Delegated Report

Householder Planning Application

Application No:	20220660
Location:	5 Dover Road East, Gravesend, Kent, DA11 0RQ
Description:	Creation of a new vehicle crossover
Applicant:	Icarus Investment Management Ltd

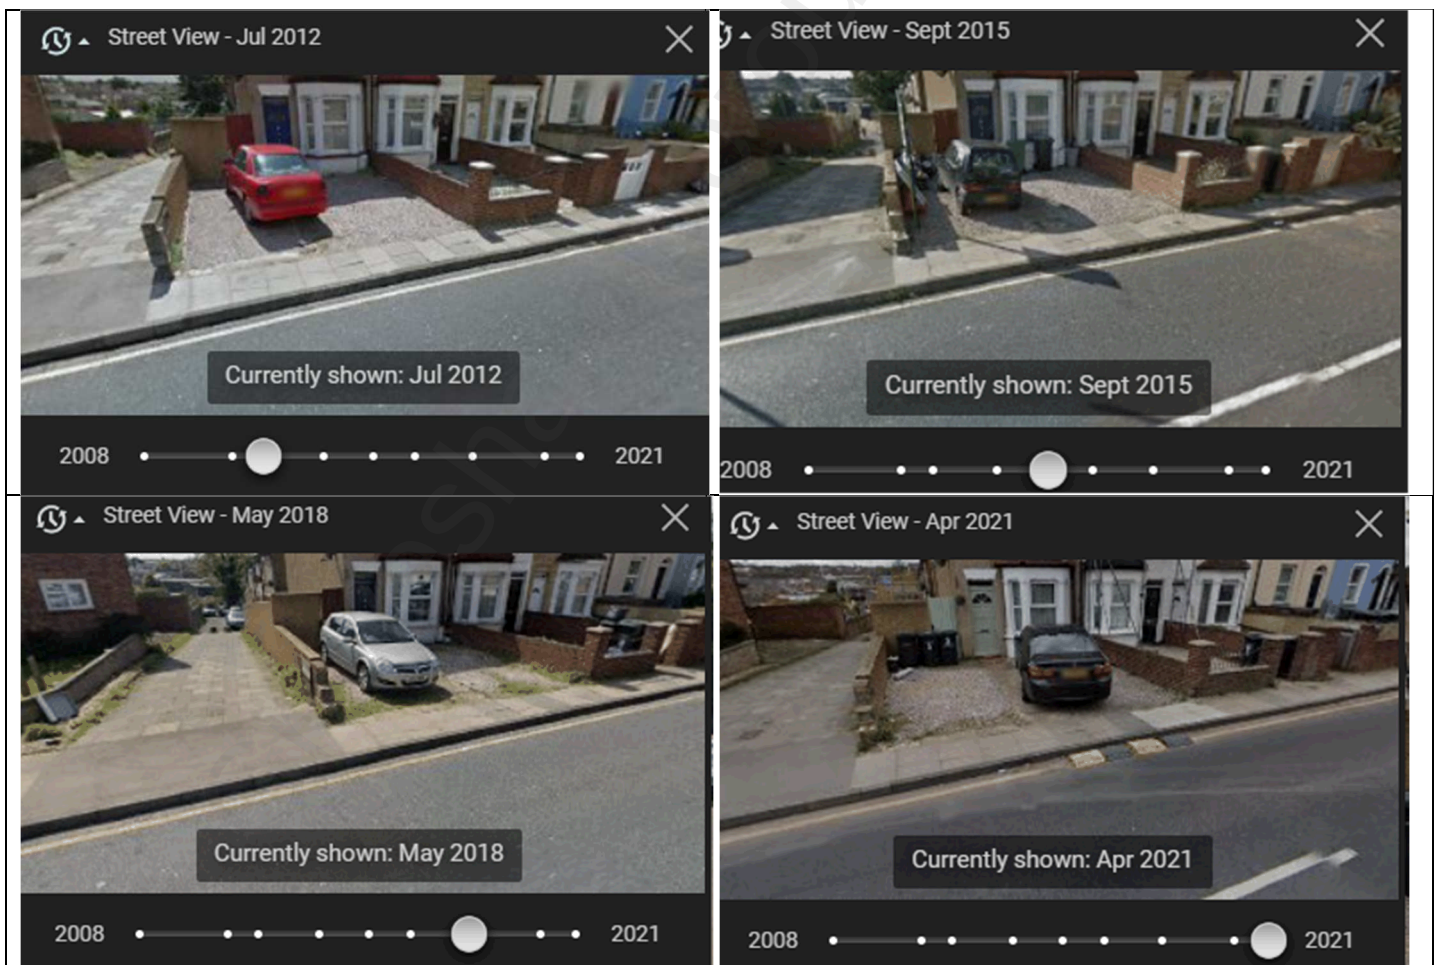
In terms of the application, I am confused by the architect's drawing in terms of what appears to be the vehicle visibility splays, Manual for Streets suggests for a 30mph road 43m x 2.4m x 43m are appropriate and this would involve I believe the splay passing over at several (perhaps 3 or 4) properties to the west. As the landscaping and boundary treatments in the front gardens of these properties cannot be fully controlled, this would be unacceptable in terms of highway safety.

As presented, this application fails to comply with the requirements of PGN6, in terms of sight lines and on site turning. I therefore recommend refusal of the application.

The proposed driveway would not significantly alter the appearance of the street scene. The plans indicate that the frontage of the property would be hard-paved, even though no details have been provided regarding the materials used in the formation of the driveway. Nevertheless, the lack of soft landscaping is considered to be poor design, contrary to guidance given in Gravesham's newly published Householder Extension/Alteration Design SPD (2021). The SPD clearly states that hardstanding should be proportionate and soft landscaped planting should be provided:

This is not the case with this application and the proposed development would result in a harsh, overdeveloped appearance which is harmful to the character and appearance of the street scene. Moreover, it is unclear if the materials will be permeable or if tarmac is the intended surfacing. Nevertheless, the development is poor design contrary to Policy CS19 (LPCS) and Section 12 (Achieving well-designed places) of the National Planning Policy Framework (NPPF) (2021).

In this case, the proposal fails to provide on site turning. Gravesham's Highways Officer has recommended that the application is refused by virtue of failing to comply with the requirements of PGN6 and has questioned the accuracy of the vehicular visibility splays. The visibility splays given by Manual for Streets (2009) states that visibility splays of 43m x 2.4m x 43m should be provided for a 30mph road. The splays annotated on 'drawing no. 001' are not setback from the highway edge by 2.4m and therefore are incorrect. The Highway Officer considers that a correct splay would pass over the land of potentially four neighbouring properties, and therefore no planning condition could control the visibility splays being impeded landscaping or boundary treatments on the neighbours land.
